IMMINGHAM EASTERN RO-RO TERMINAL

Document Information		
Project	Immingham Eastern Ro-Ro Terminal	
Document Title	Applicant's Response to Natural England's Deadline 6 Submissions	
Commissioned by	Associated British Ports	
Document ref	10.2.69	
APFP Reg 2009	Regulation 5(2)(q)	
Prepared by	IERRT Project Team	
Date	Version	Revision Details
11/12/2023	01 Deadline 7	Submitted at Deadline 7

Image 1. Waders feeding in close proximity to the jack-up barge

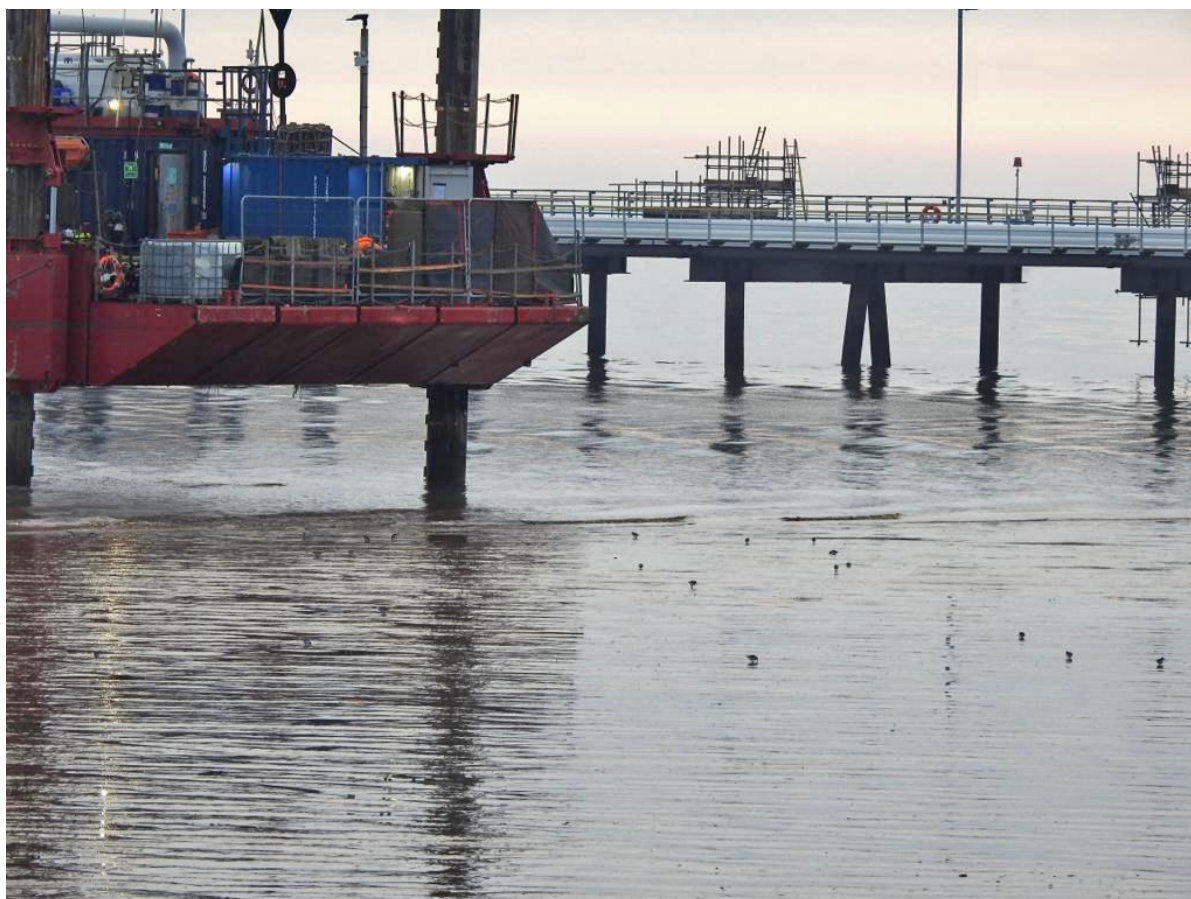
- 3.7 **At point 1) Natural England note** that Appendix E of the HRA includes Fig E.1 which shows noise modelling for piling on the outer pier, but does not include Fig 2 which shows noise modelling on the inner pier and approach jetty. It is suggested that this information is required for a thorough assessment. Natural England state that Fig 1 and Fig 2 of the predicted airborne noise (L_{Amax}) during piling indicate that beyond 200m from the noise source noise levels will be below 70 dB and that this is considered to define the area that will result in the majority of bird disturbance. Natural England acknowledges that 200 m is an acceptable disturbance distance for most construction activities within a port environment where birds will show some habituation to human activity. However, Natural England advise that a precautionary approach is taken to noise disturbance distances for piling. We [Natural England] recognise that birds are highly likely to be disturbed where noise levels exceed 70 dB L_{Amax}. However, there may also be effects on birds between 55 and 70 dB, whilst Natural England recognise that this noise level impacts on a large area of mudflat, Natural England consider that 200 m does not represent a precautionary approach and advise that the noise disturbance zone should be larger, such as 300 m from noise source.

- With respect to visual stimuli associated with the piling activity, as specified in the HRA Report (paragraphs 4.10.19 and 4.10.20), evidence from the disturbance monitoring of the IERRT Ground Investigation ("GI") works which used a jack-up barge (which will also be used for the IERRT piling), recorded limited disturbance with Black-tailed Godwit, Shelduck and other SPA species feeding within 60 m and in numbers in the local area comparable to previous years (see Image 1). On this basis, 200 m is also considered appropriate with respect to visual stimuli associated with piling activity.

3.13 It is acknowledged that the potential for some limited responses in more sensitive species such as Shelduck cannot be ruled out at distances of more than 200 m from piling. However, such responses at these distances would be expected to be mild and very infrequent given the evidence on the known habituation to existing port related activity and noise. On this basis and as detailed in the HRA Report, the winter marine construction restriction is considered effective at minimising disturbance and allowing birds to continue to feed in the footprint of the Project during the winter months. Specifically, as highlighted in Table 30 of the HRA Report, disturbance of the magnitude predicted is not considered to compromise any of the conservation objectives the Humber Estuary SPA/Ramsar site.

Figure 1. Position of the tide at different tidal states during a spring tidal phase

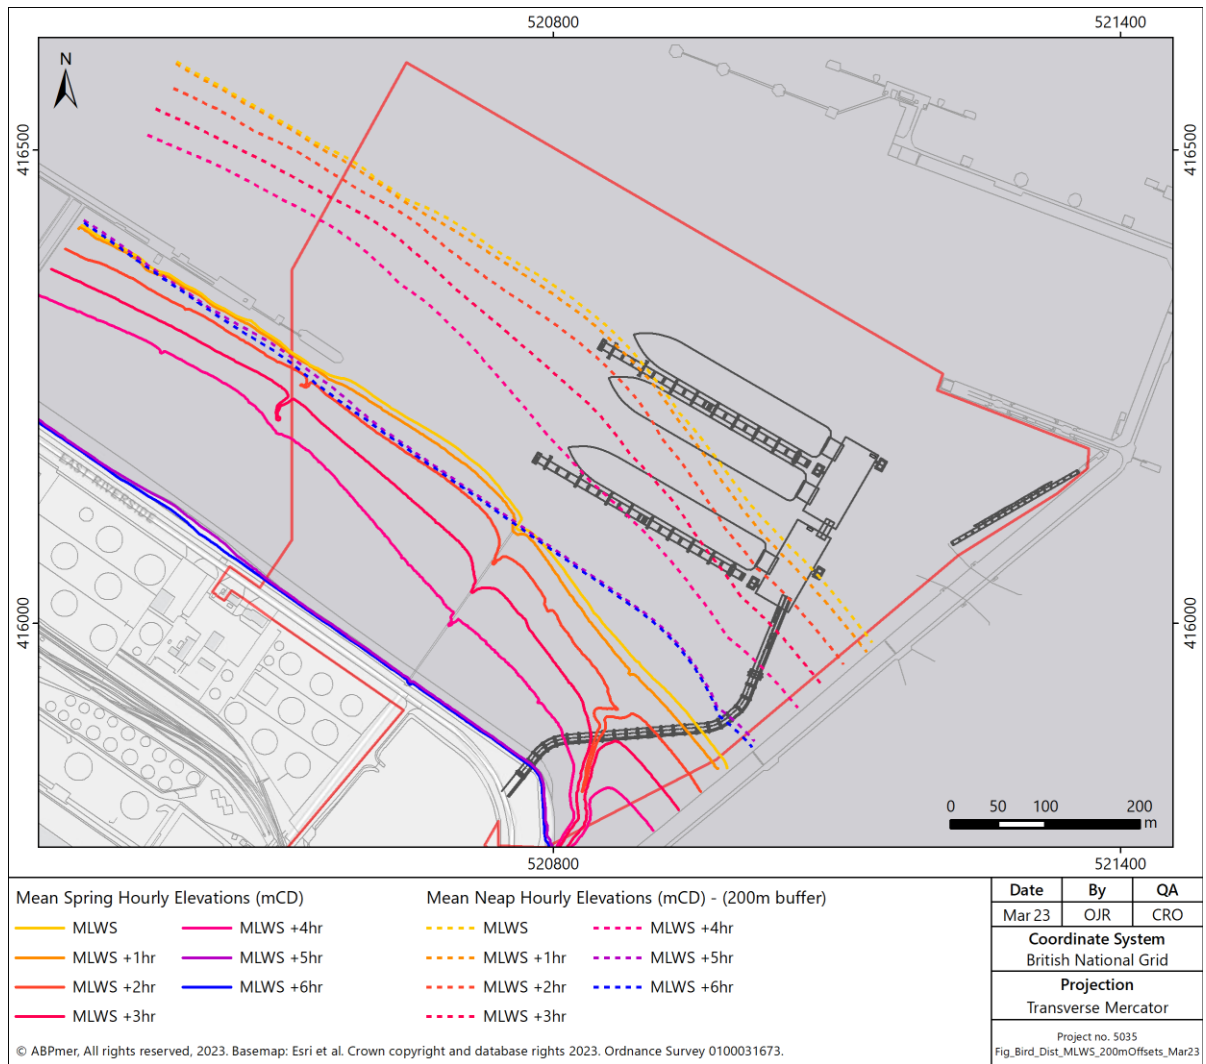
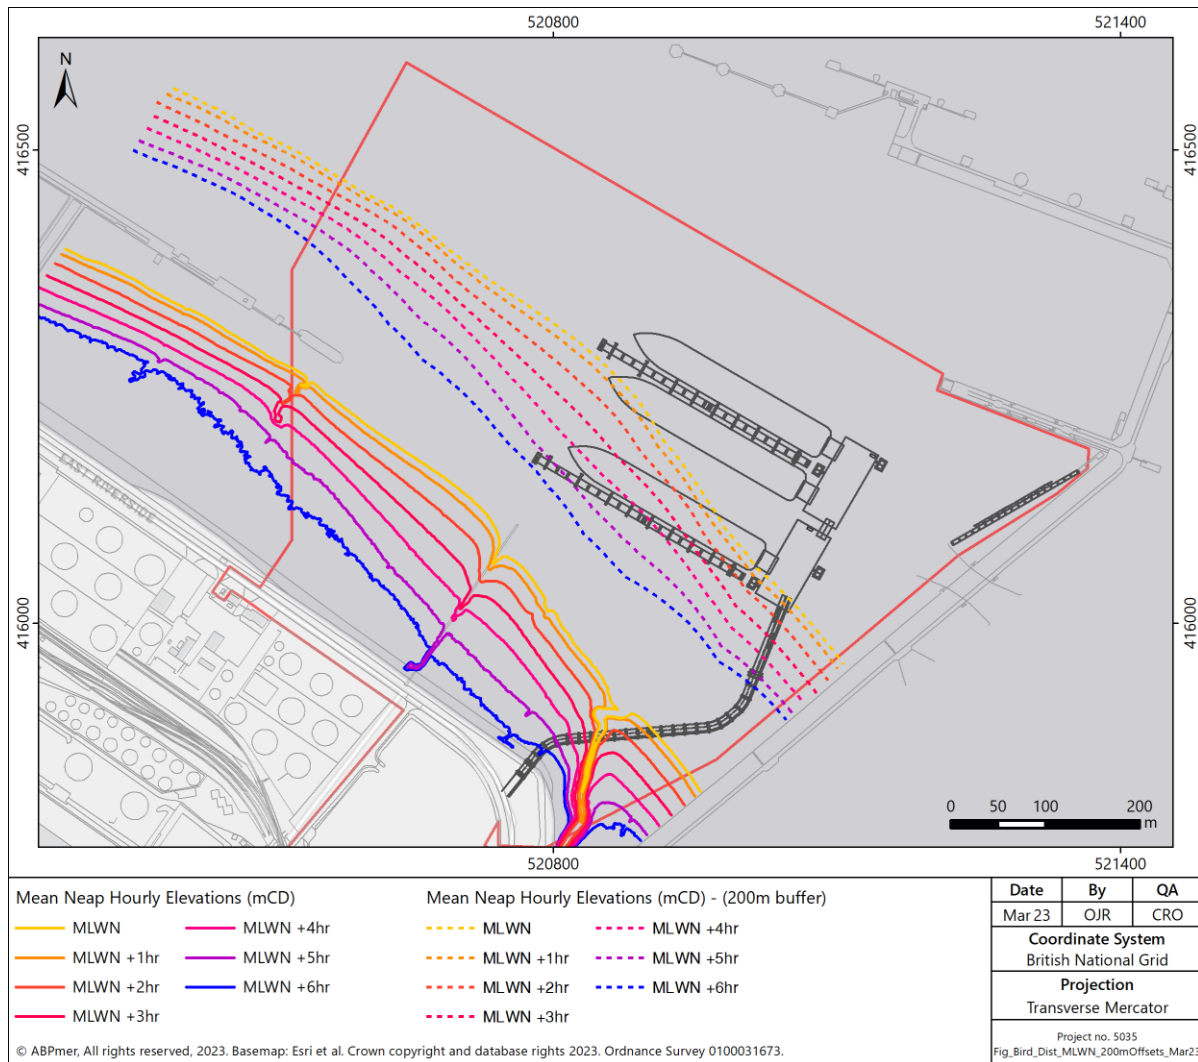
- 3.15 **At point 2) Natural England state** the following: *'With respect to the proposed mitigation measures for impacts of noise on non-breeding birds: Construction activity (including piling) not allowed within 200m of exposed mudflat (2 hours either side of high water when the works should be approximately 200m from mudflats)'. This applies to the approach jetty and inner pier only. With reference to Fig 2 it is unclear how this will be applied when working on the upper shore especially work on the approach jetty. Clarity is needed about the area of mudflat covered by the tide in different tidal states. Please provide more information on tide levels in the port and whether the mudflats will be covered with sufficient depth of water which will deter use by the majority of SPA waterbirds at all high tides.*

- 3.16 The position of the tide and the area of mudflat covered by the tide in different tidal states (along with corresponding 200 m buffer distances from the tide mark) is provided in Figure 1 and Figure 2 below, for mean spring tides and mean neap tides, respectively.

- 3.17 Waders and other shorebirds typically forage on exposed intertidal areas or in very shallow water depths (<5-10 cm deep¹). Water depth is rapidly expected to reach depths unsuitable for most SPA waterbirds to feed within a localised area around the tideline (several metres) based on the analysis of the foreshore profile (i.e., slope gradient).
